# **As-Built Baseline Monitoring Report**

## **Russell Gap Mitigation Project**

**Subject:** Response to DMS Comments for DRAFT As-Built Monitoring Report  
Russell Gap Mitigation Project, Alexander County  
DMS Project # 100003, DEQ Contract #6980, Catawba River Basin

Please find enclosed our responses to the NC Division of Mitigation Services (DMS) review comments dated August 28, 2020 in reference to the Russell Gap Mitigation Project - DRAFT As-Built Monitoring Report. We have revised the draft document in response to the review comments as outlined below.

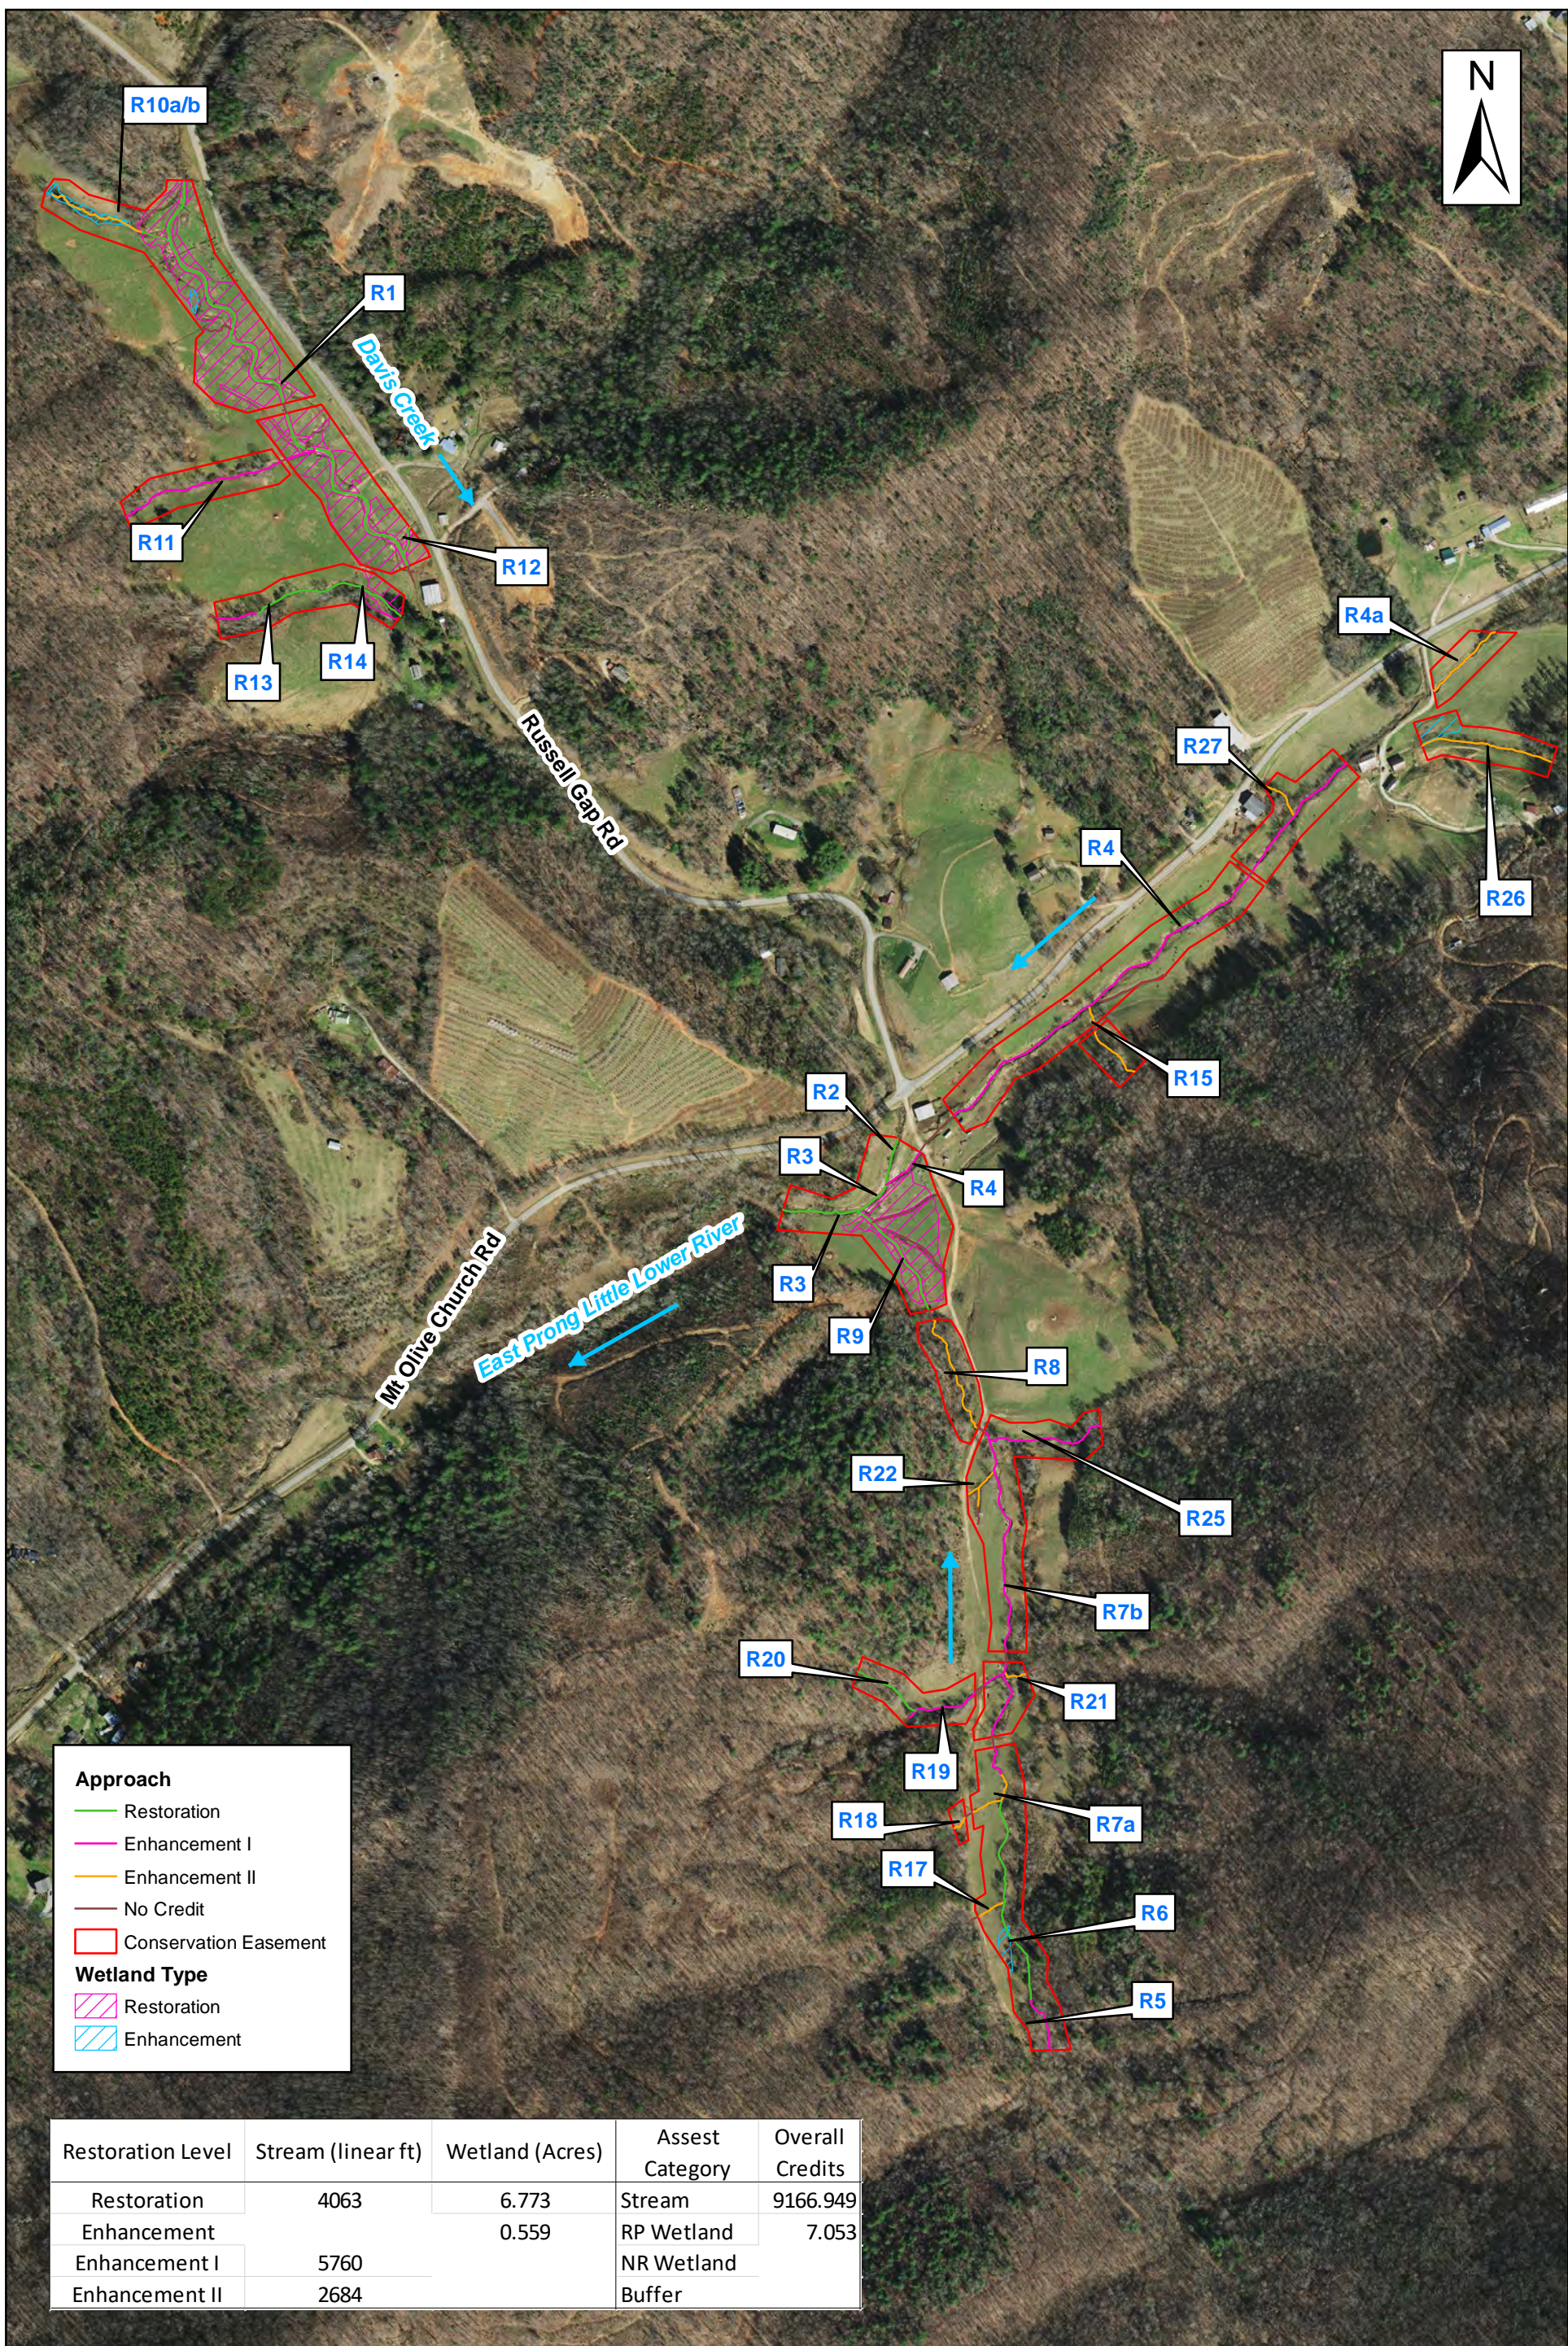
- Figure 2: There are two bold green lines shown on R9 floodplain. Based on figures in the Mitigation Plan, this appears to be jurisdictional wetlands. Recommend turning layer off for this Figure.

**Response: Revision made as requested.**
- Figure 2: Please revise the overall credit table at the top of the figure to show credits discussed in previous comment.

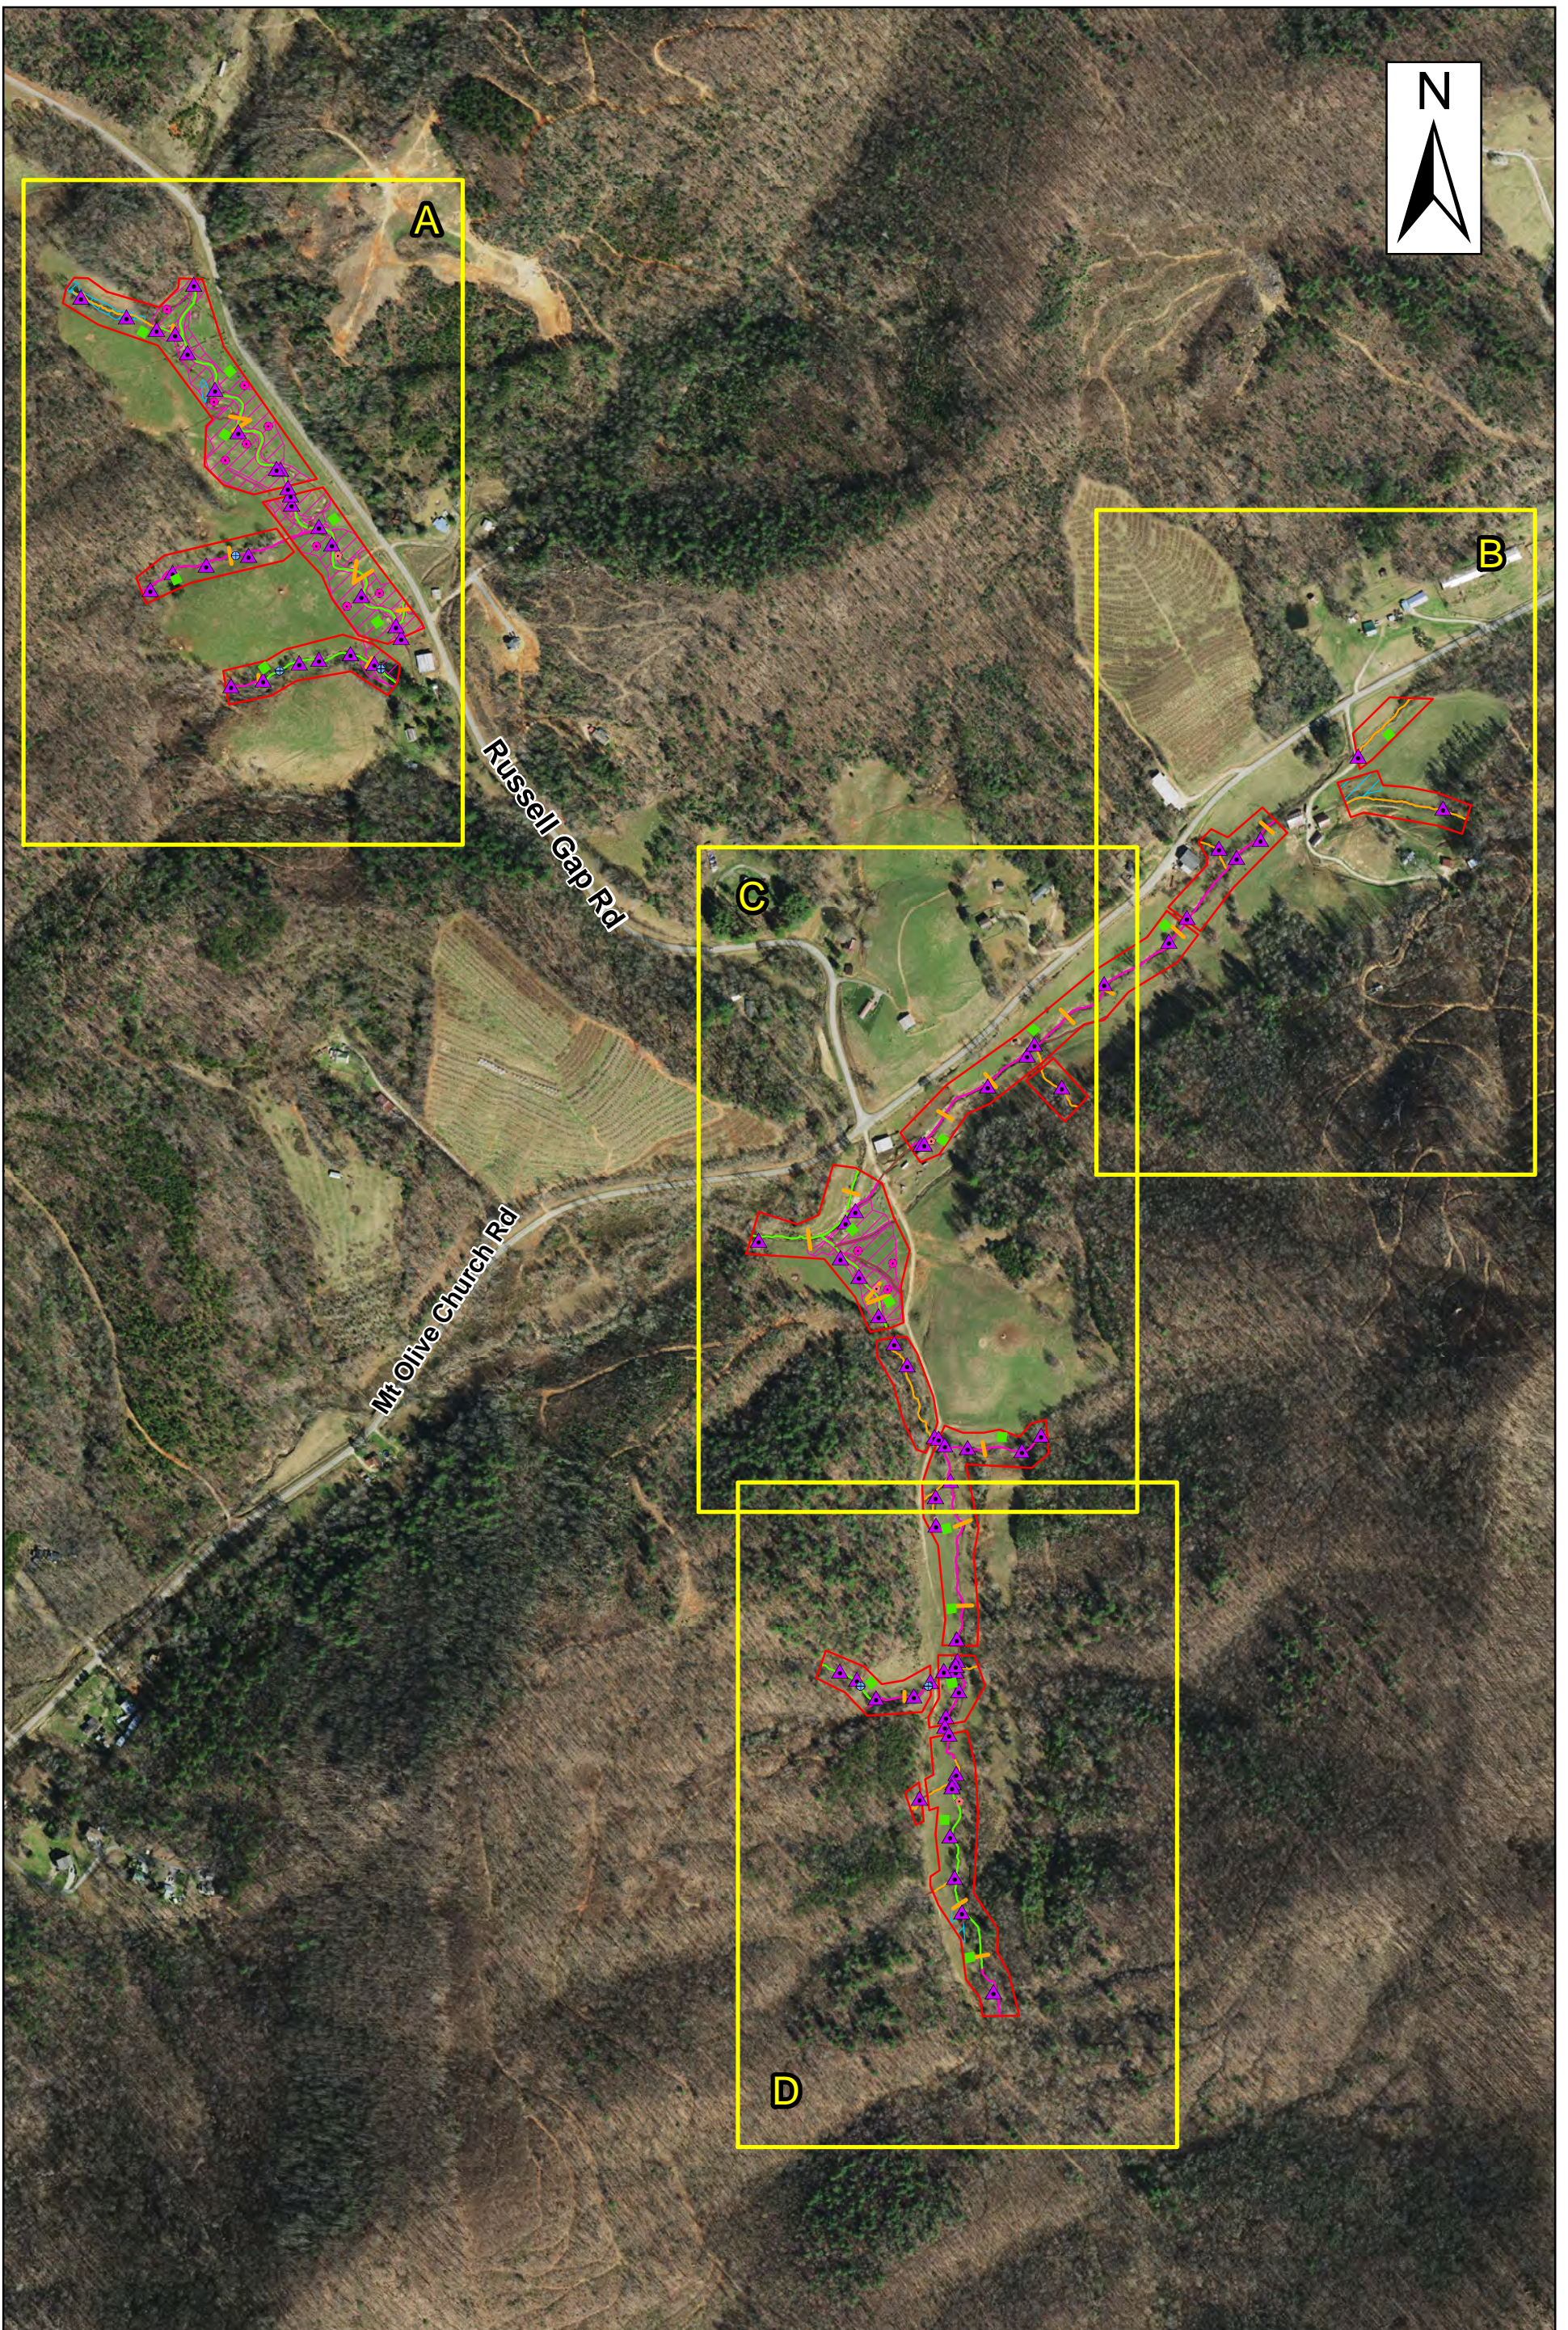
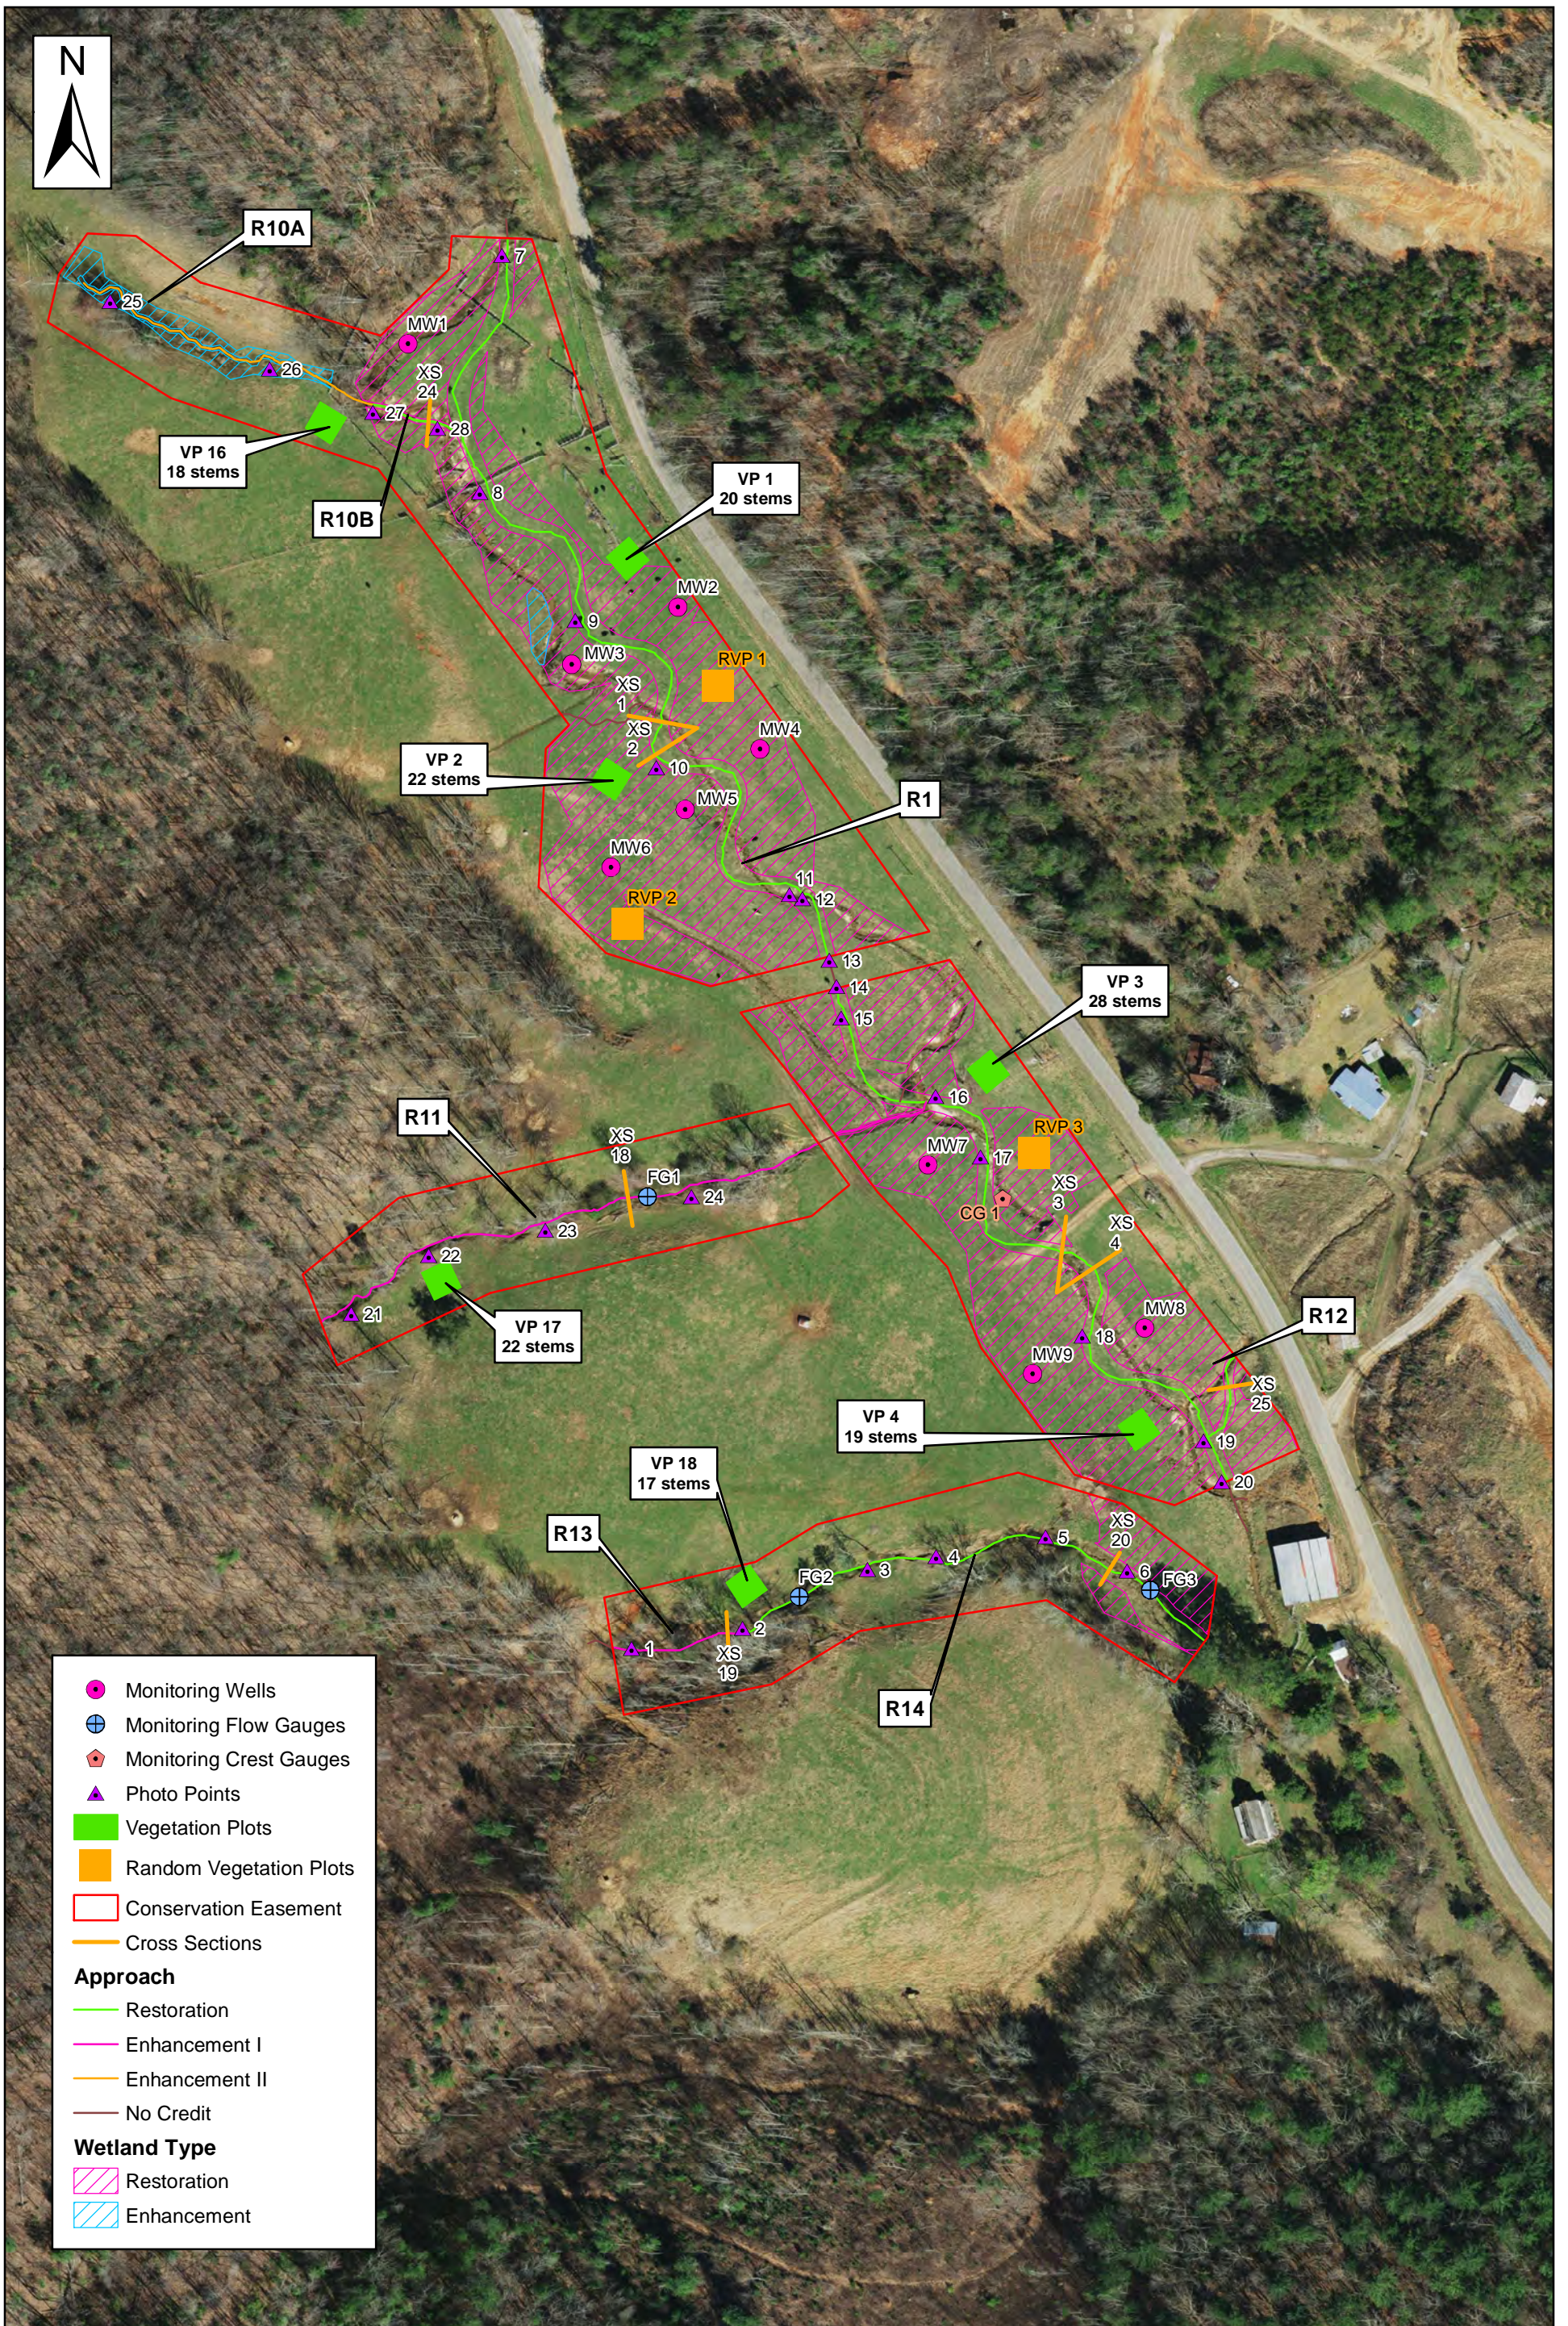
**Response: Revision made as requested.**
- Figure 3: Please add location of Random Vegetation Plot to CCPV.  
**Response: Revisions made as requested.**

- Figure 3B: Label XS8  
**Response: Revision made as requested.**
- Figure 3C: Label XS8, XS10  
**Response: Revisions made as requested.**
- Figure 3D: Label XS21, XS22

**Response: Revisions made as requested.**
- Stream Station Photo Points: Photo resolution is very poor in the draft report. Please update for final.  
**Response: All stream photos have been redownloaded and updated into the final report as requested.**
